UNITED STATES PATENT AND TRADEMARK OFFICE

APPLICATION NO.	FILING DATE	FIRST NAMED INVENTOR	ATTORNEY DOCKET NO.	CONFIRMATION NO.
09/681,441	04/05/2001	Peter Fall	VCC0031-US	4762

Office Action Summary

Fig. 1

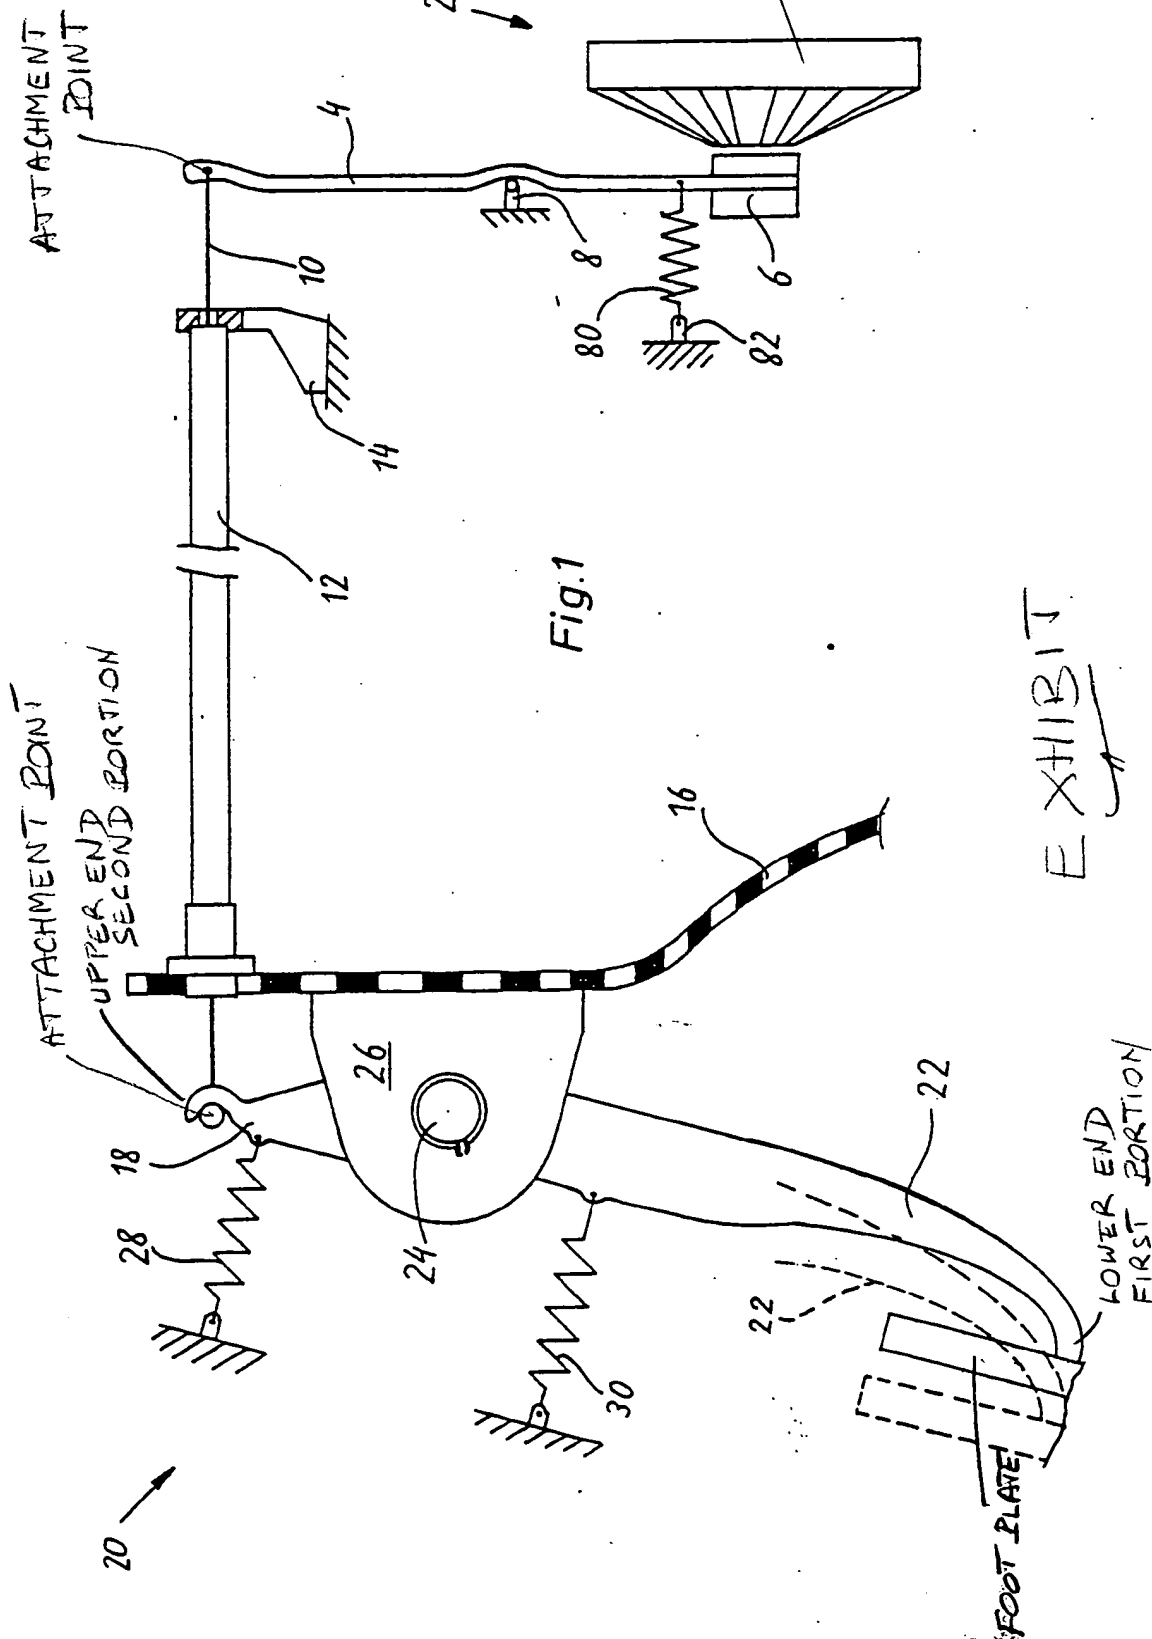
a foot plate (unnumbered, see Exhibit attached) fixed to a first portion (at 22 in Fig. 1) of the pedal arm 22 on one side of the pivot axis;

wherein the motion-transmitting element 10 is disposed so that the distance between the motion-transmitting element's attachment points (see Exhibit) to the respective arms (18 and 4) is maintained at least substantially constant when there is a tensile force on the element 10 (i.e., when the foot plate is moved downwardly as shown by solid line position in Fig. 1) and is allowed to be shortened when there is compressive force on the element 10 (i.e., when the foot plate is moved upwardly as shown in dashed line position in Fig. 1); and

“With regard to the Bayer reference, Fig. 1 clearly shows that the cable 10 is pivotably joined at one end to the lever 18. The cable joint at the opposite end is only schematically illustrated, but there is no reason why a person skilled in the art should not take it for granted that also the joint between the cable and the lever 4 is pivotable because there is no indication or suggestion to the contrary. Further, one of skill in the art should appreciate that it is common practice to arrange pivotable joints at both ends of a control cable of the type shown in the Bayer reference.”

The applicant's above assertions explicitly admits that Bayer's motion-transmitting element 10 is joined firstly to a second portion of the pedal arm 22 and secondly to the pivotally mounted lever 14 as claimed. There is a reason why a person skilled in the art should take it for granted that the joint between the cable and the lever 4 is also pivotable because Fig. 1 of Bayer indicates so. In fact, Bayer's lever 4 is pivoted by swinging back and forth at the pivot point 8 in order to engage and disengage the operating device 2. It is well-settled law that an anticipatory reference needs not duplicate word for word what is in the claims. Anticipation can occur when a claimed limitation is “inherent” or otherwise implicit in the relevant reference. *Standard Havens Products Inc. v. Gencor Industries Inc.*, 21 USPQ2d 1321, 1328 (CAFC 1991).

Applicant contended that nowhere in Bayer reference is there any indication that a telescoping rod may be used. Contrary to applicant's subjective observation, Bayer's Fig. 1 shows the cable core 10 sliding within the conduit 12, therefore, the cable core 10 and conduit 12 form a telescoping member. There is a reason why a person skilled in the art should take it for granted that the joint between the cable and the lever 4 is also pivotable because Fig. 1 of Bayer indicates so. In fact, Bayer's lever 4 is pivoted by swinging back and forth at the pivot point 8 in order to engage and disengage the operating device 2. *Standard Havens Products Inc. v. Gencor Industries Inc., supra.*
